RE: 9508 Riverdale Lane NW
Grading and Drainage Plan
Engineer's Stamp Date: 02/06/23
Hydrology File: C13D027H

Based upon the information provided in your submittal received 02/07/2023, the Grading & Drainage Plan is approved for Grading Permit (earthwork can get started for the earth pad on the house).

LOPEZ — MIKE SANCHEZ, CRESCENT — GRADING & DRAINAGE PLAN

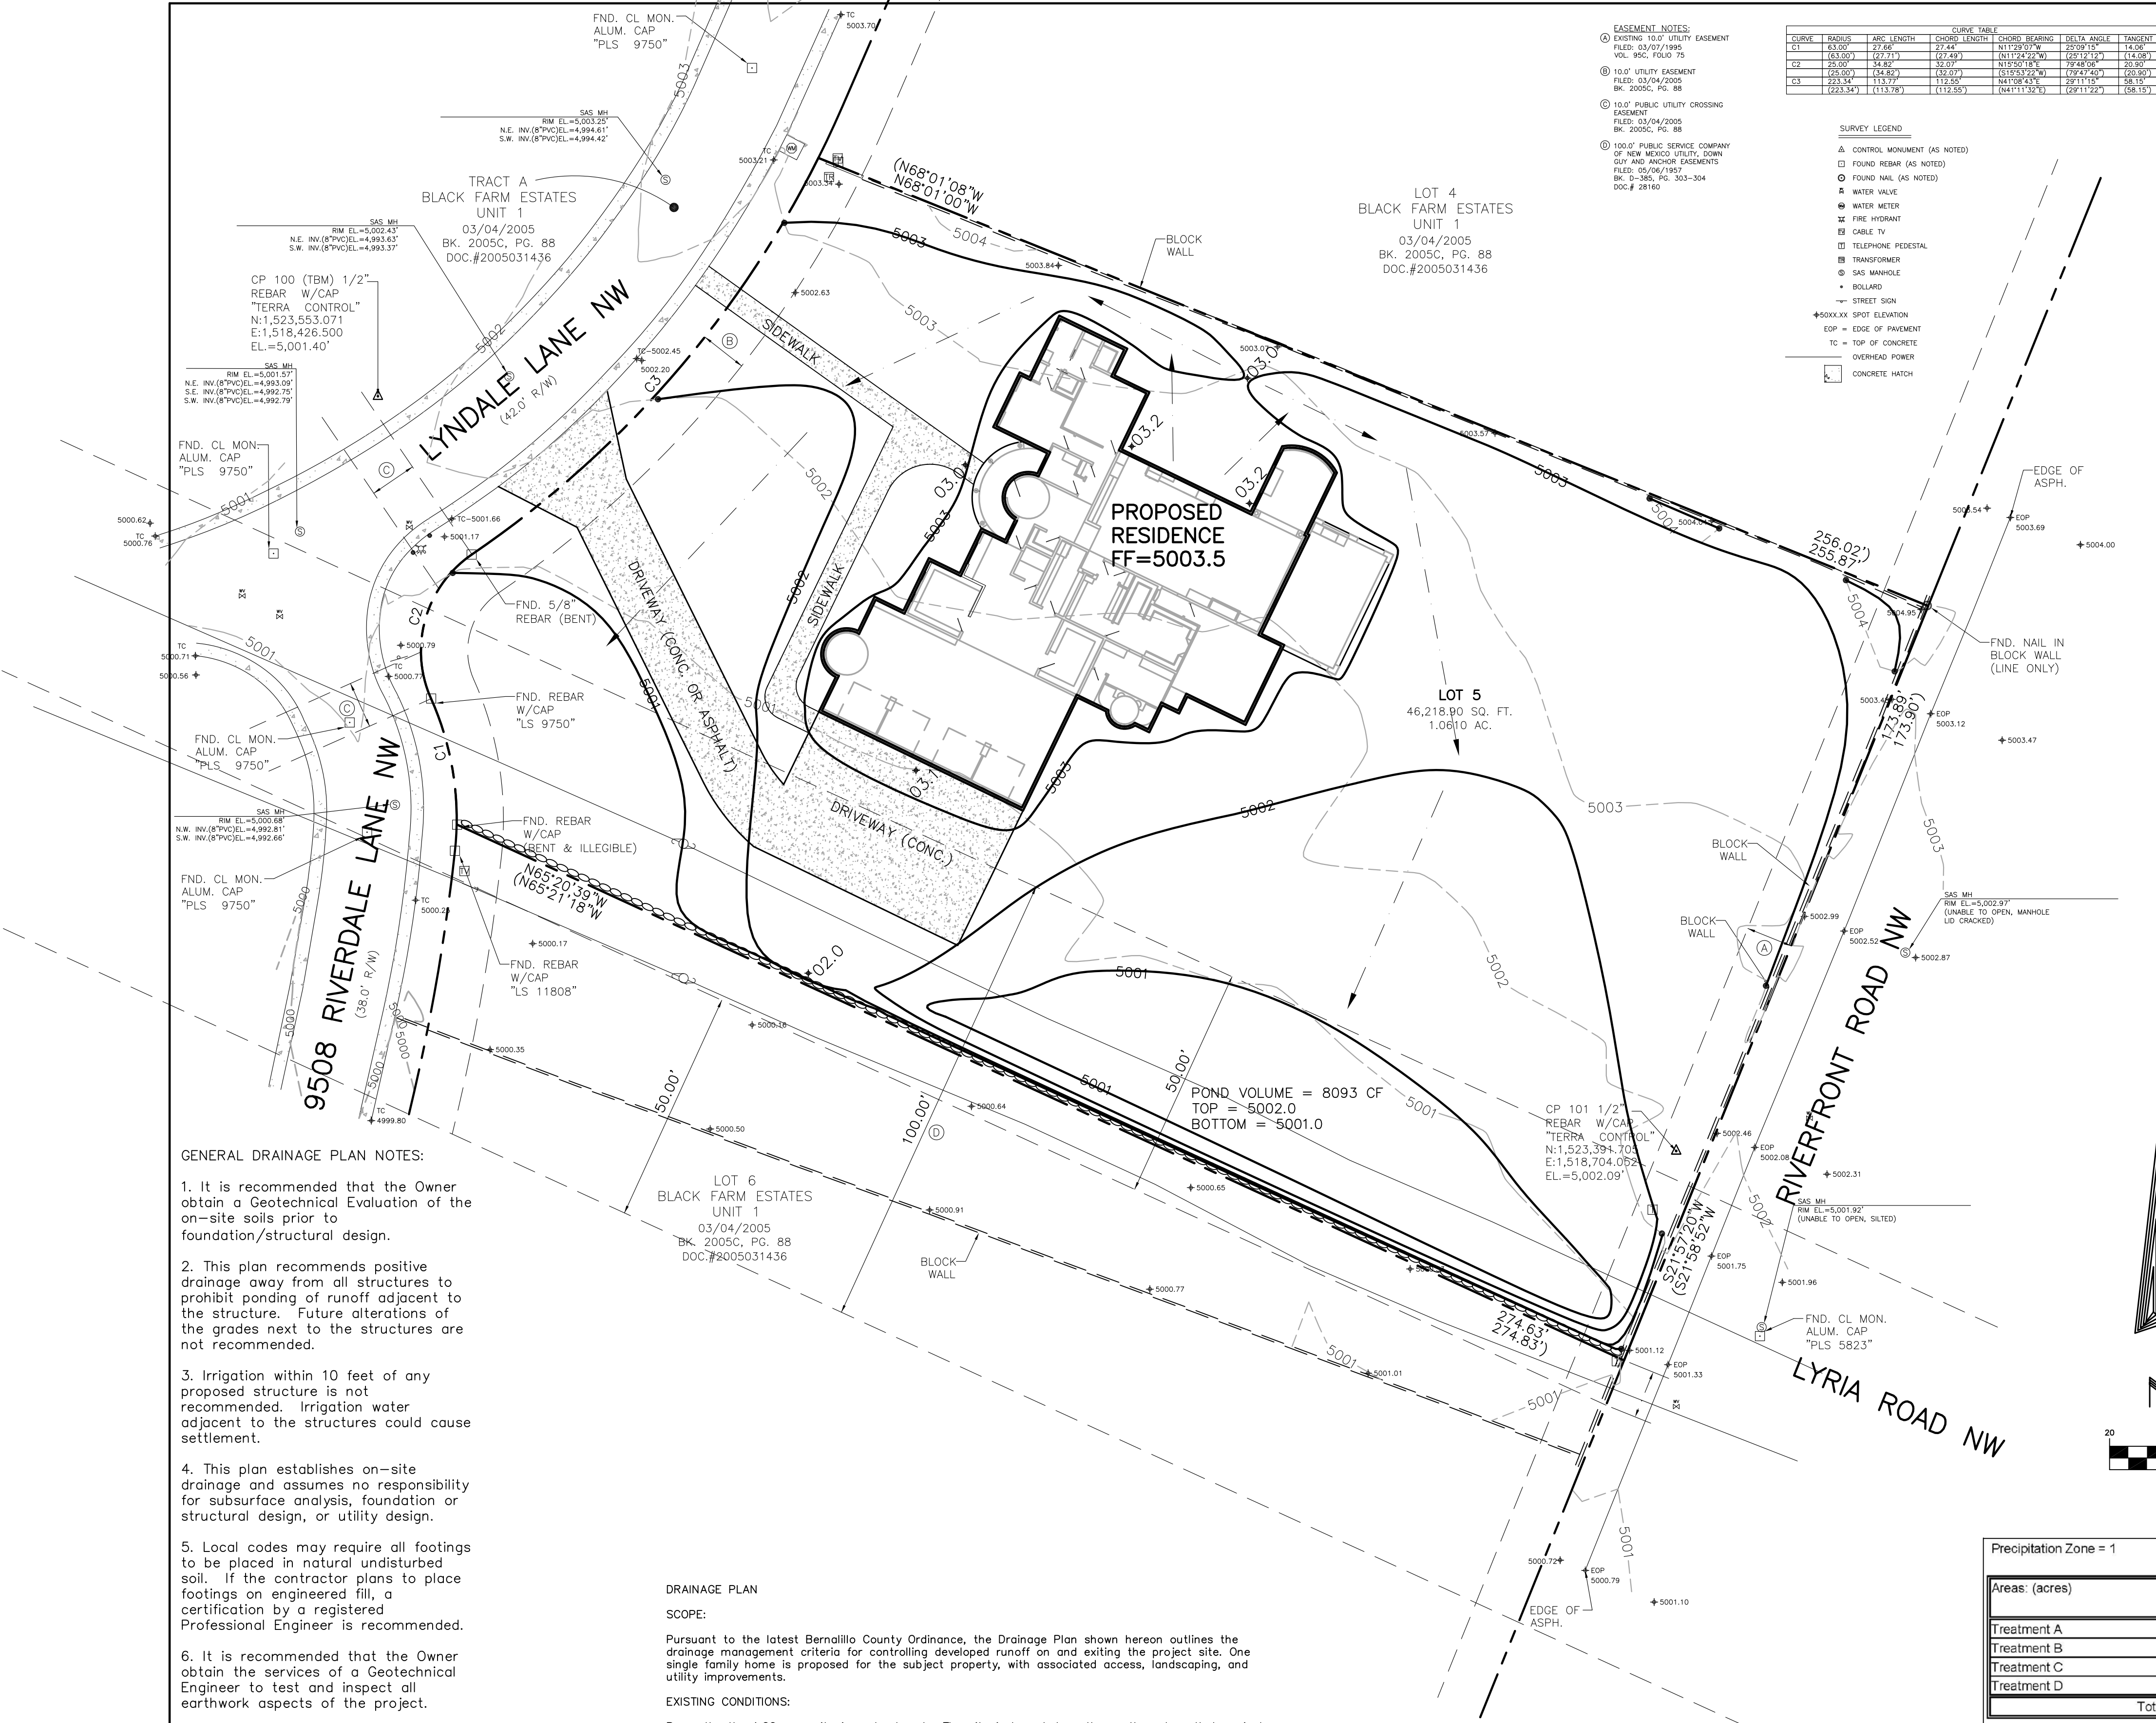
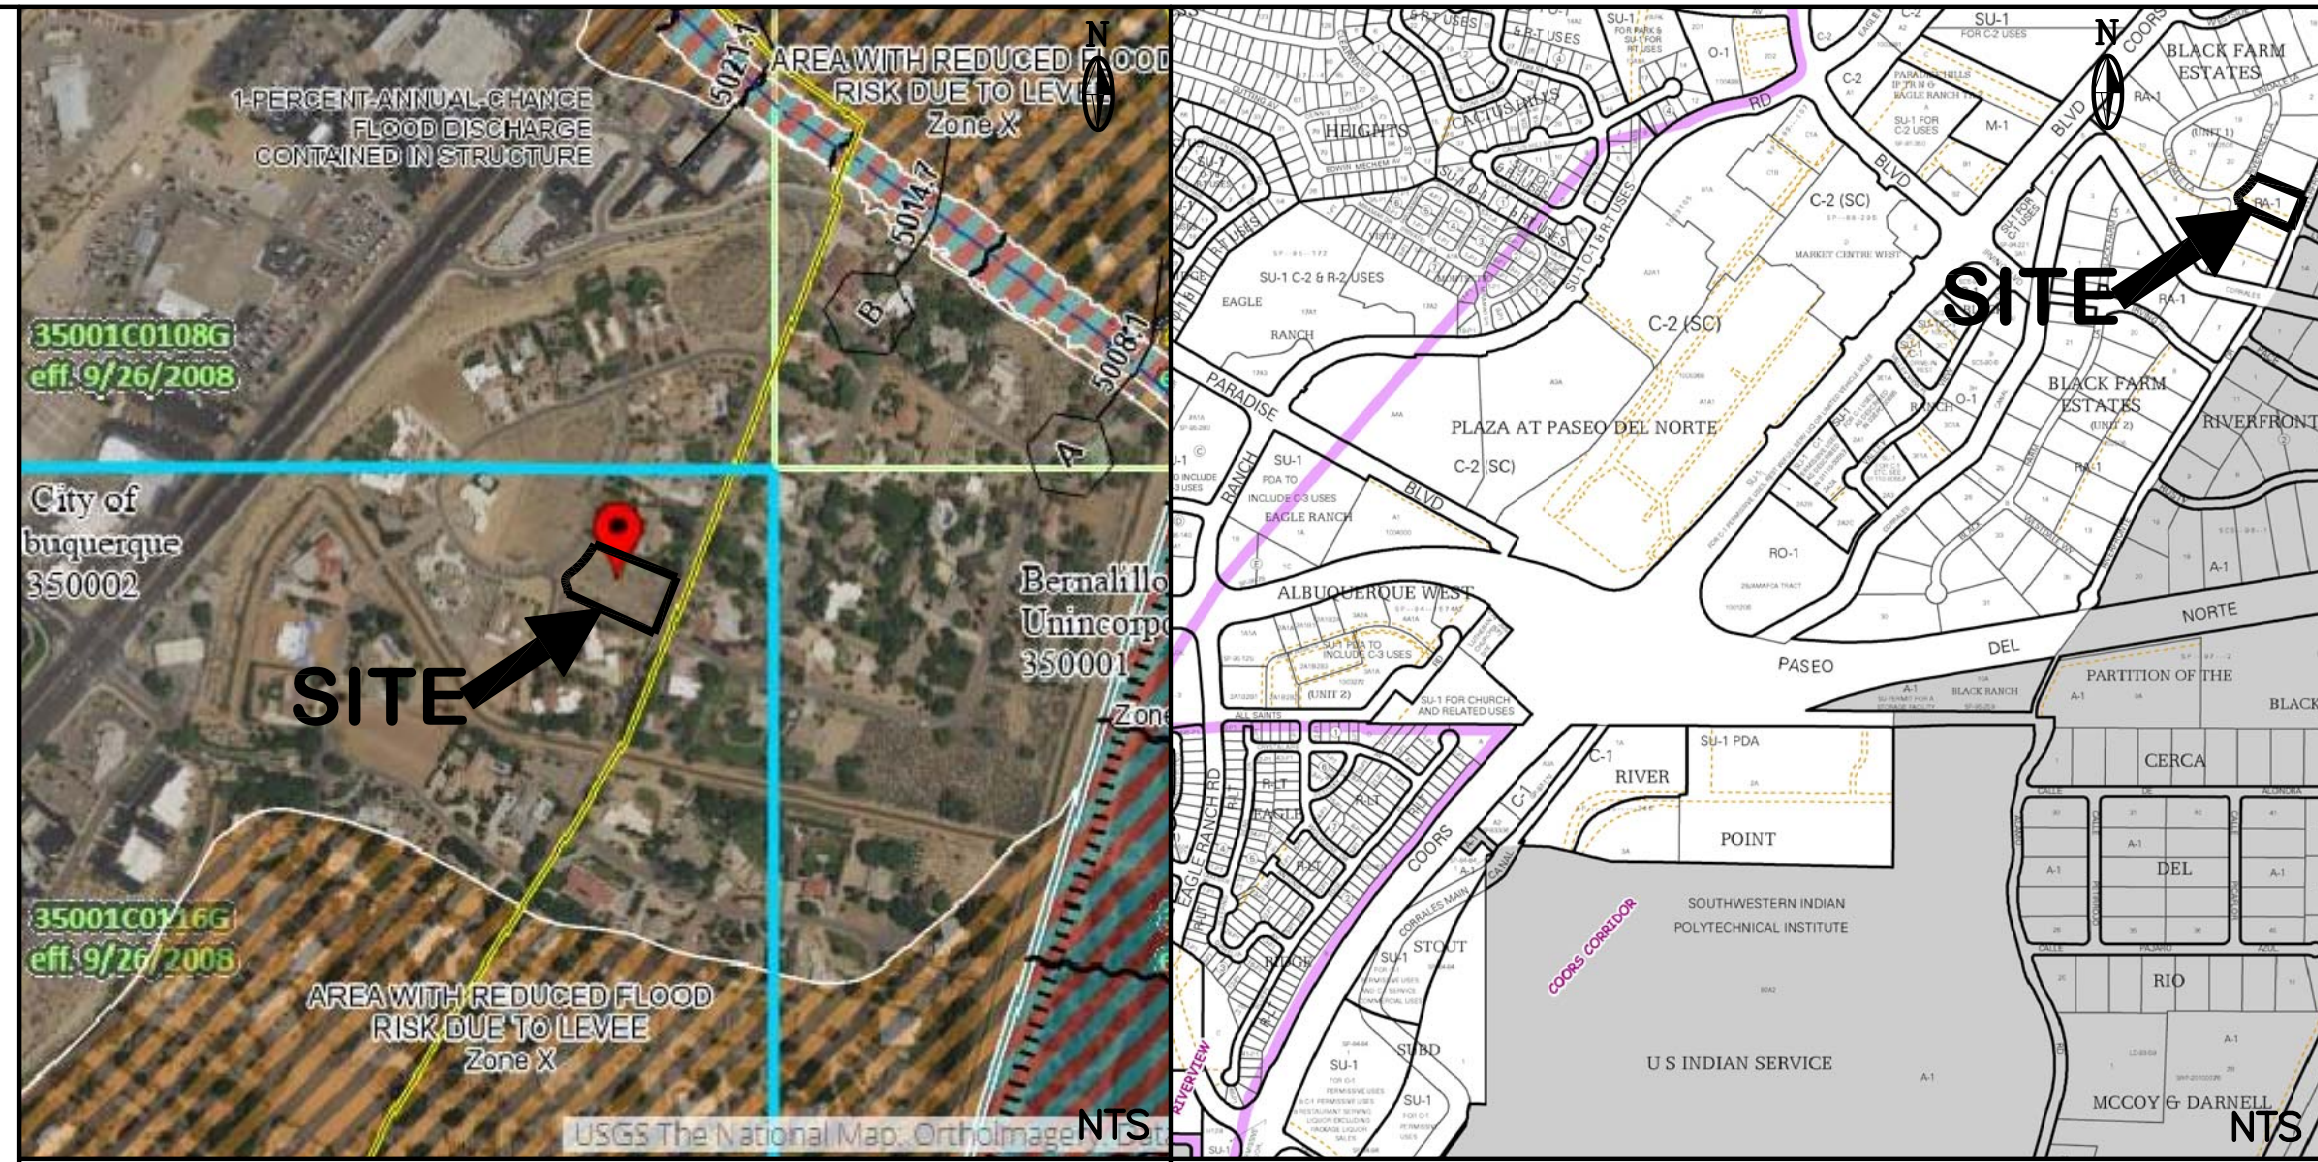
1. Once the grading is complete, a pad certification (meaning that the earthwork is complete) will be required. **Please include a site photo with the submittal.** Also, at the time of pad certification approval, Hydrology will concurrently approve the Grading & Drainage Plan for Building Permit.
